Five Estuaries Windfarm DCO

PINS Ref: EN010115

Date: 3 December 2024

Planning Act 2008**Application by Five Estuaries Offshore Wind Farm Limited for an order granting development consent for the Five Estuaries Offshore Wind Farm project.**

Tree Preservation Order 91/00021

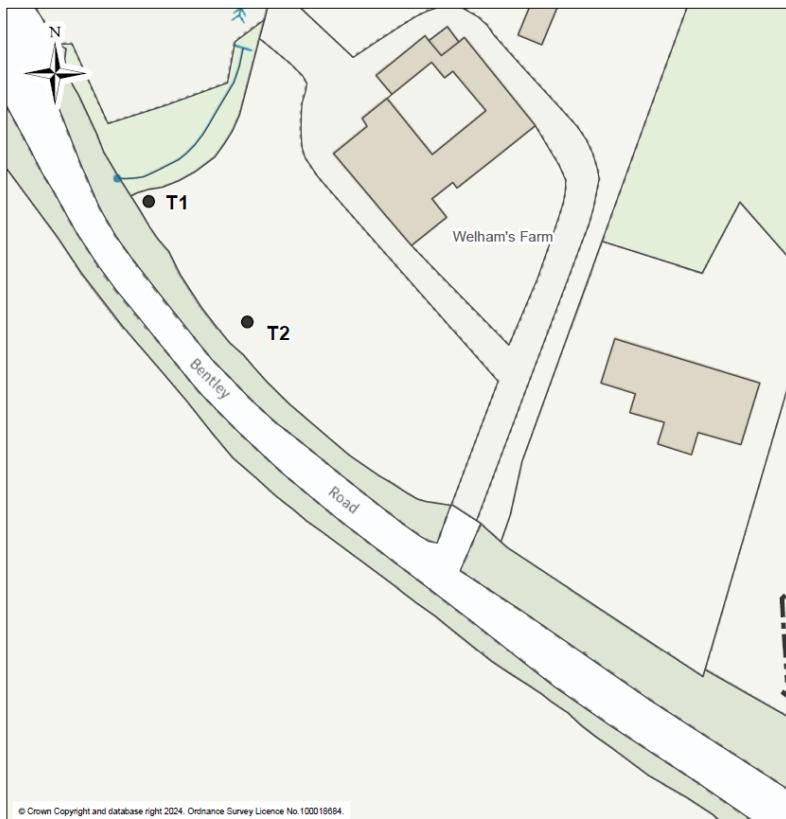
submit wording that you consider would address those concerns.	would like the wording found in Appendix 1 - Construction Hours (from a recently Consented DCO) to be considered for inclusion.
EO.2.01	Tendring District Council (TDC) and Applicant	<p>TPO Trees and Veteran Trees</p> <p>Table D Tree Preservation Orders (TPOs) in Arboricultural Report [APP-255] provides only a reference number, with a broad description identifying only the number of trees present. Appendix B (Tree Constraints Plans), Drawing Number 2 Sheets 28 of 47 and 37 of 47 illustrate the presence of TPO trees with a non-specific Tree Preservation Order Location (yellow star) or Tree Preservation Order Tendring District Council 2023 (cross-hatched yellow).</p> <p>a) For TDC - in respect of Sheets 28 and 37 only, provide drawings at a scale 1:500 identifying any specific trees, by identification number/mark, which are likely to be impacted or subject to mitigation.</p> <p>b) For TDC – in respect of Sheets 28 and 37 only, are any of the trees identified as Veteran?</p> <p>c) For Applicant - where impacts are likely to occur on the TPO trees referenced above, whether in the form of pruning, lopping, root reduction or felling, provide reasons/justification for these actions and details of mitigation proposals to minimise the level of impact likely to occur.</p>	<p>a) TDC are satisfied that the arboriculture impact assessment is an accurate reflection of the age, quality and condition of the trees. TDC expects to see the root protection area applied to all TPOs that may be affected by the proposals. The root protection area needs to be applied to the following trees;</p> <ul style="list-style-type: none"> - Sheet 28: 23/00005/TPO trees in G1 oak and tree T1 also oak (see attached Sheet 28 23_00005TPO 1-500.pdf at Appendix 2) - Sheet 37: 91/0021/TPO tree T2 a silver maple (see attached Sheet 37 91_00021TPO 1-500.pdf at Appendix 2) <p>b) TDC does not have this information as we do not record Veteran trees.</p>
